PART 36 PERMIT APPLICATION

Surface Waste Management Facility (19.15.36 NMAC)

Permit Application (4th Submittal) Reply to Tentative Decision

Request for Additional Information – Reply to Tentative Decision Letter dated 02/07/13 Tentative Decision for Proposed Commercial SWMF

Sheet 1 of 17 Boundary Survey

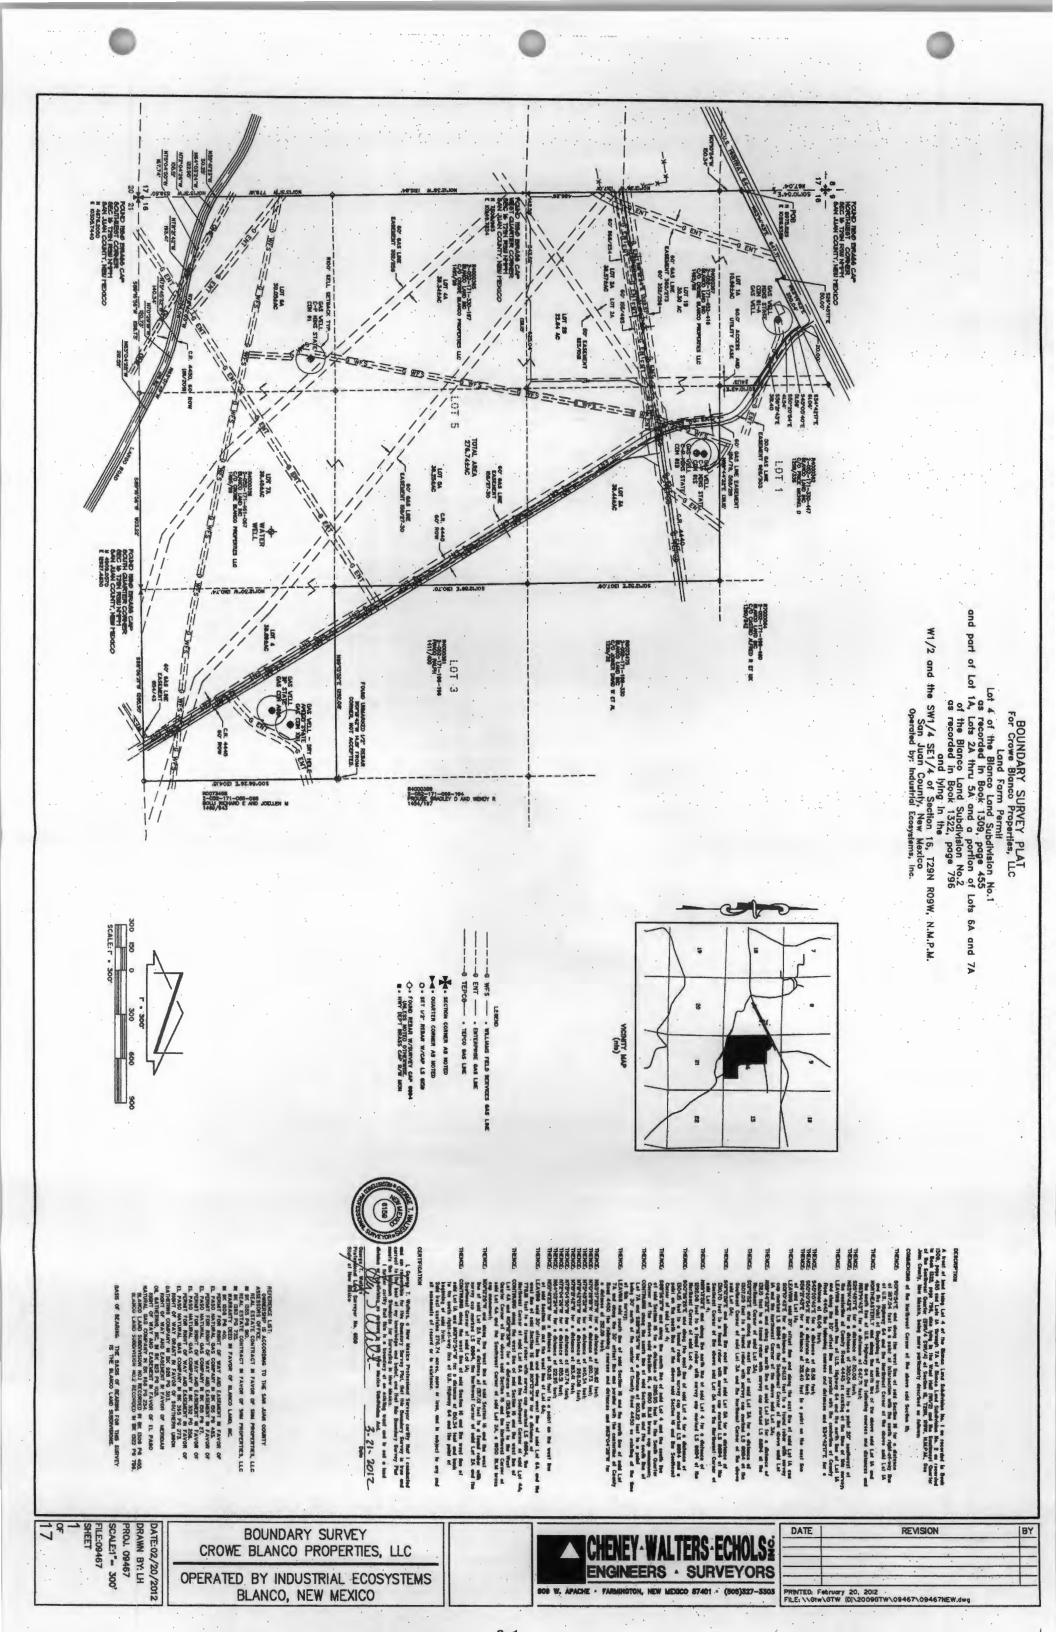
Page 2.1, Sheet 1 of 17, Boundary Survey:

Page 4.2, Sheet 1 of 17, Boundary Survey:

Sheet 11 of 17 Homes Within 1 Mile

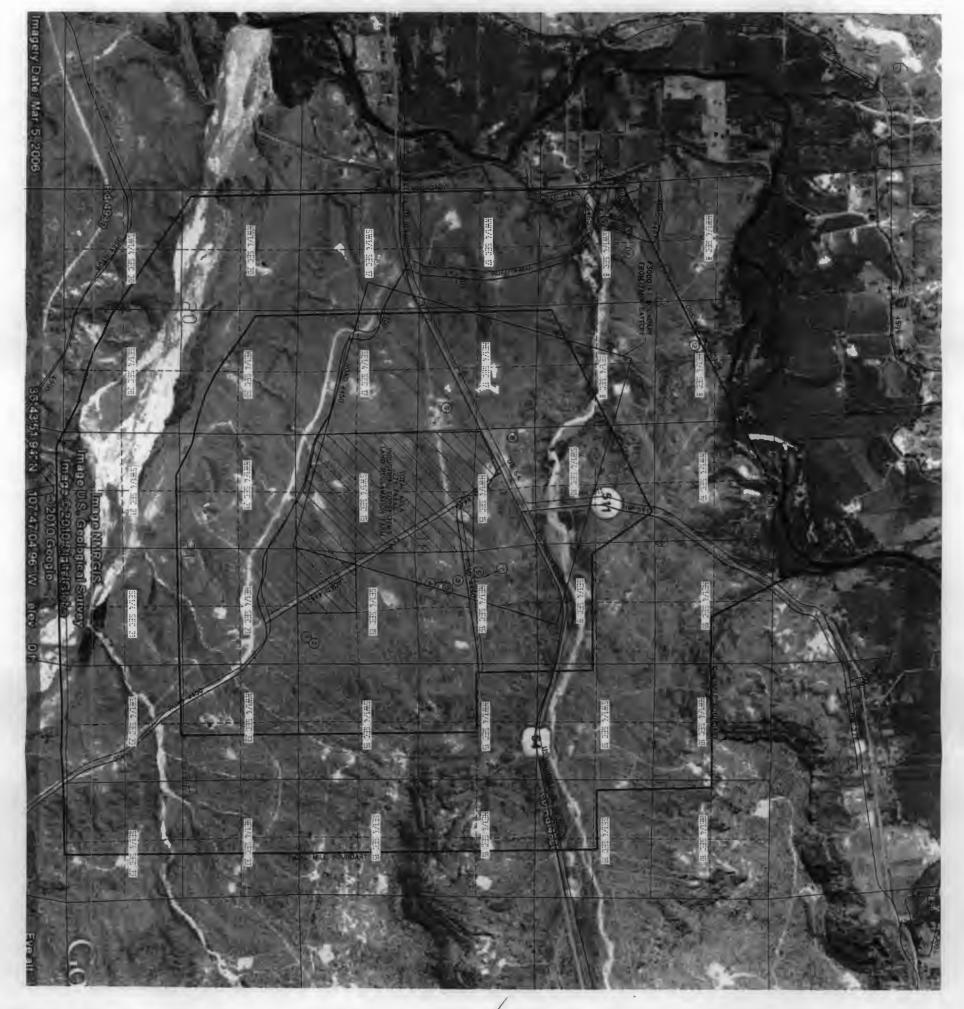
Page 2.3, Sheet 11 of 17, Homes Within One Mile:
